Re: proposed Littleton Wind Farm comprising of 11 no. turbines and all associated works.

PROPOSED LITTLETON WIND FARM, CO. TIPPERARY.

Observation – Incomplete EIA / Visual Impact Assessment

Glengoole / New Birmingham, Reen Rd Viewing Area - Assessment of Landscape & Visual Effects.

Location- View No.1

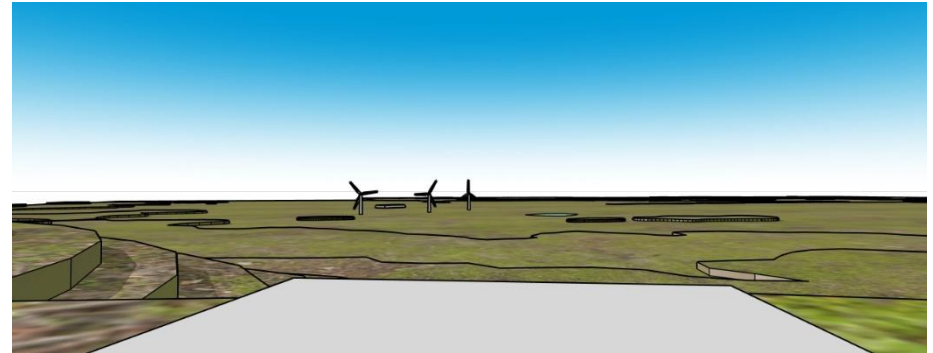
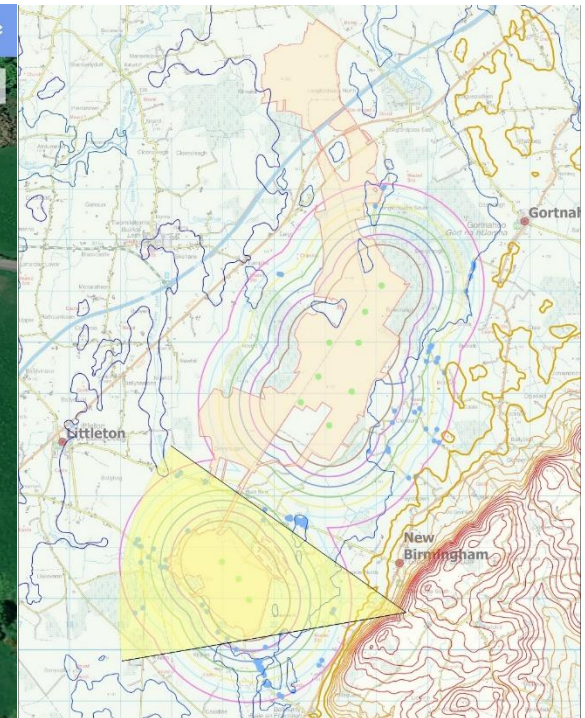
- **Scenic values of views** – View looking over Tipperary plains towards Maugherslieve Mountain at 543m above sea level
- **Sensitive landscape views** - Maugherslieve Mountain is Class 5 - Table 5.2 Sensitivity Rating of Landscape Character Area. (C.D.P)

- **Intensity of use and popularity** - Local, regional, national & international.
- **Connection with the landscape** – Observation and reflection, communal dining picnic area provided.

- **Provision of elevated panoramic views** - 180° panoramic
- **Degree of perceived naturalness** - non interrupted
- **Presence of striking or noteworthy features**- North Tipperary highlands.

- **Historical, cultural or spiritual value** - The Druids Altar: remains of megalithic structure sited above picnic area at 293m above sea level. TS048-041: Megalithic structure Observable from viewing area.

- **Rarity or uniqueness of the view** - The only designated viewing point on the Slieveardagh Hills sitting at 253m above sea level.
- **Sense of place** - Local Amenity and music traditional music venue.

- **Sense of awe** – un – paralleled Sunset.

Location- View No.2

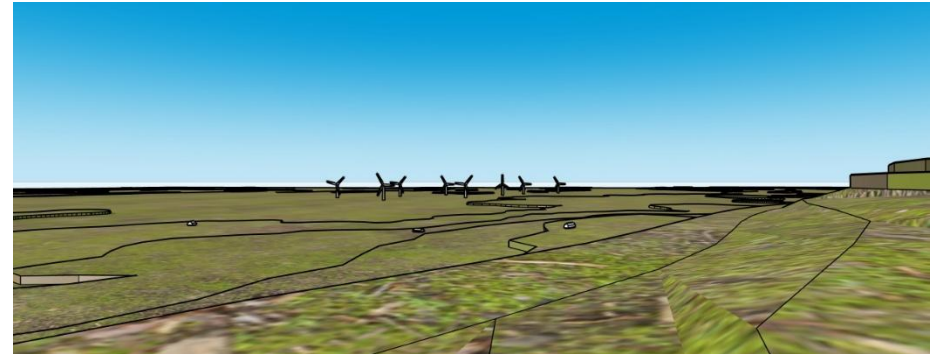
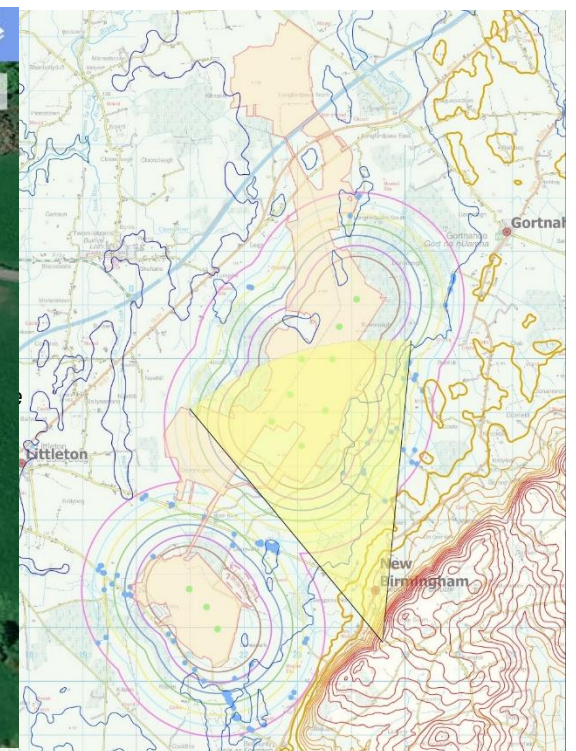
- **Scenic values of views** –Glengoole / New Birmingham in the middle ground and Arderin mountain 527m above sea level in the background.
- **Sensitive landscape views** -Class 2/ Class 5 - Table 5.2 Sensitivity Rating of Landscape Character Area. (C.D.P)

- **Intensity of use and popularity** - Local, regional, national & international.
- **Connection with the landscape** – Observation and reflection, communal dining picnic area provided.

- **Provision of elevated panoramic views** - 180° panoramic
- **Degree of perceived naturalness** – Historical village development and cumulative Impacts of wind farms at Lisheen and Brukrana.

- **Presence of striking or noteworthy features**- Glengoole Village.
- **Historical, cultural or spiritual value** - The Druids Altar: remains of megalithic structure sited above picnic area at 293m above sea level. TS048-041: Megalithic structure. Observable from viewing area.

- **Rarity or uniqueness of the view** - The only designated viewing area on the Slieveardagh Hills sitting at 253m above sea level.
- **Sense of place** - Local Amenity and music traditional music venue.

- **Sense of awe** – Sense of community and connection to village.

Location- View No.3

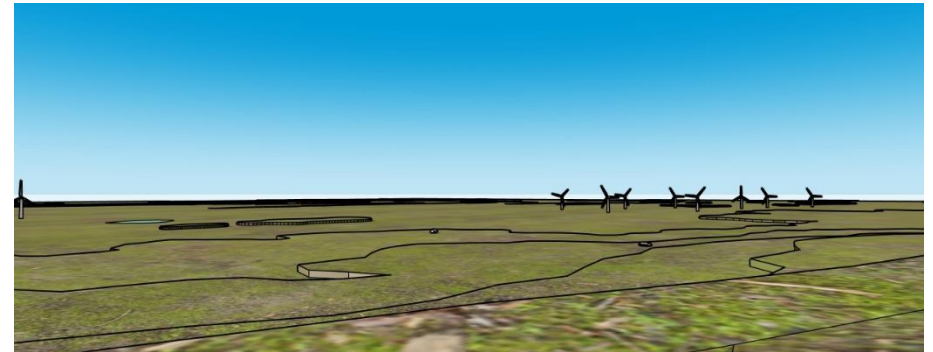
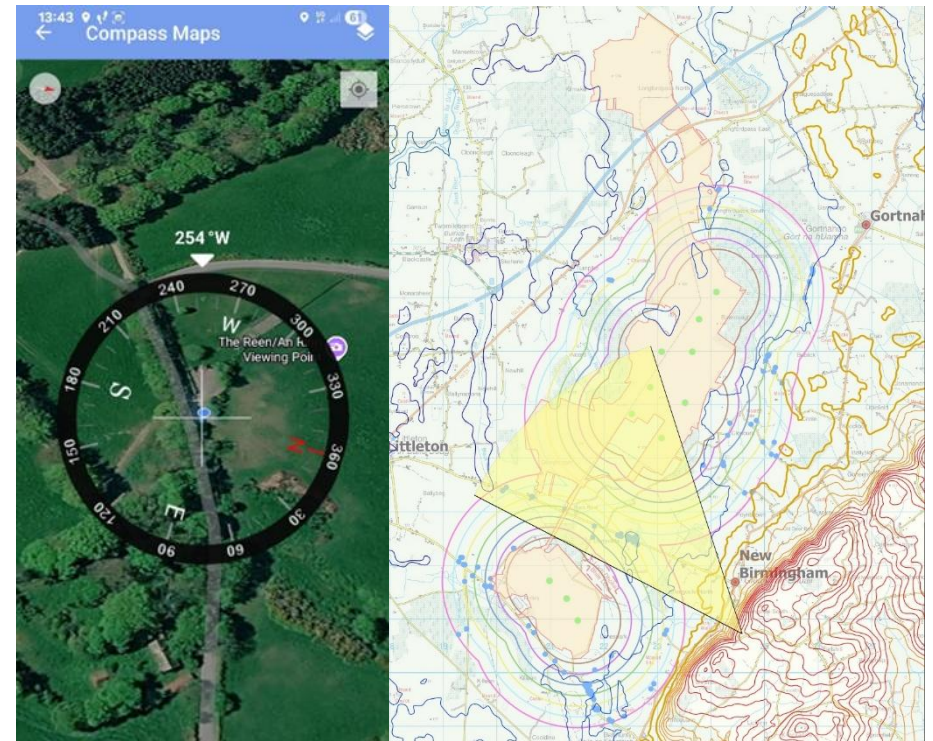
- **Scenic values of views** –Devils Mountain at 480m above sea level. Gleng
- **Sensitive landscape views** -Class 5 - Table 5.2 Sensitivity Rating of Landscape Character Area. (C.D.P)

- **Intensity of use and popularity** - Local, regional, national & international.
- **Connection with the landscape** – Observation and reflection, communal dining picnic area provided.

- **Provision of elevated panoramic views** - 180° panoramic
- **Degree of perceived naturalness** – Non interrupted views over the Tipperary plains.
- **Presence of striking or noteworthy features**- Devils Bit.

- **Historical, cultural or spiritual value** - The Druids Altar: remains of megalithic structure sited above picnic area at 293m above sea level. TS048-041: Megalithic structure. Observable from viewing area.

- **Rarity or uniqueness of the view** - The only designated viewing area on the Slieveardagh Hills sitting at 253m above sea level.
- **Sense of place** - Local Amenity and music traditional music venue.

- **Sense of awe** - place and connection to village.

Location- View No.4

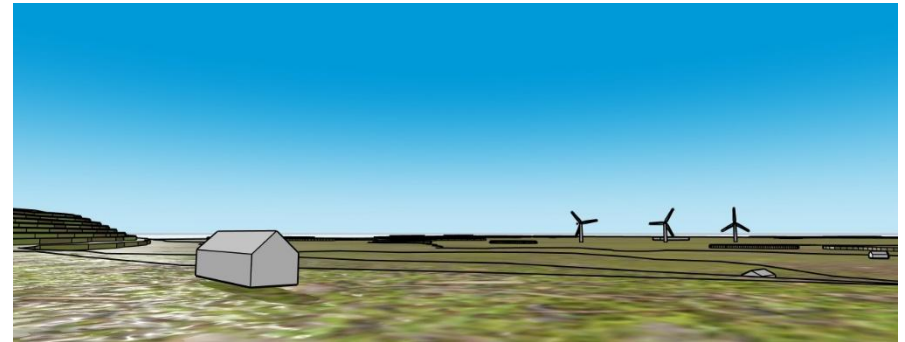
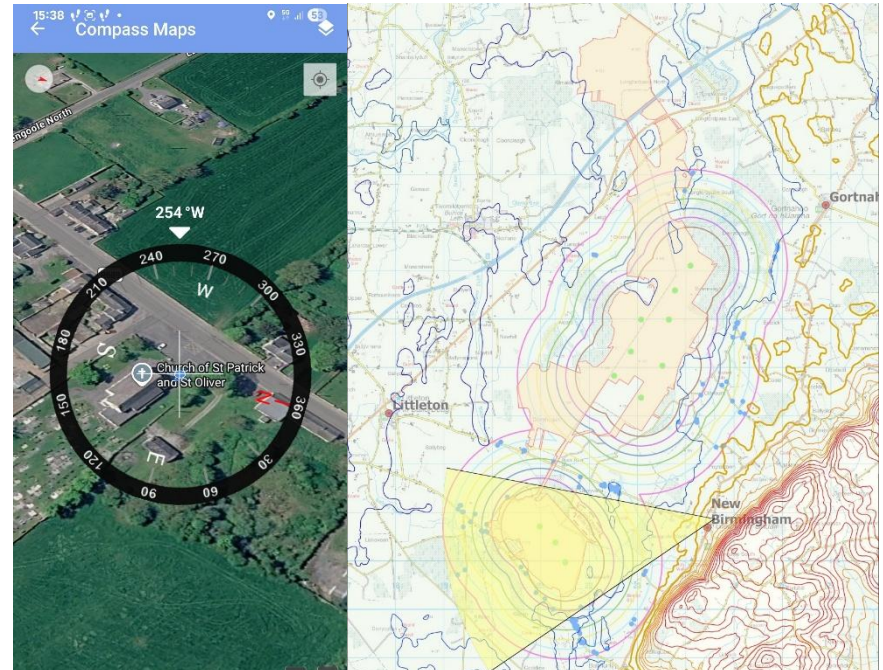
- **Scenic values of views** – Killough Hill at 197m above sea level northwest to the west. Kill Hill at 222m and Galtymore Mountains at 917m above sea level to the southwest.

- **Sensitive landscape views** - Class 5 - Table 5.2 Sensitivity Rating of Landscape Character Area. (C.D.P)
- **Intensity of use and popularity** - Local, regional, national.

- **Connection with the landscape** – reflection due to spiritual setting of church on site.
- **Provision of elevated panoramic views** - 180° panoramic

- **Degree of perceived naturalness** – Glengoole Village & cumulative impacts of wind farms at Kill Hill detract perceived naturalness. Undisturbed naturalness to west

- **Presence of striking or noteworthy features**- Killough Hill to north west.
- **Historical, cultural or spiritual value** – Church settlement and burial ground since 1815.

- **Rarity or uniqueness of the view** – elevated village.
- **Sense of place** - Quaint rural Irish Village.
- **Sense of awe** - Sunset
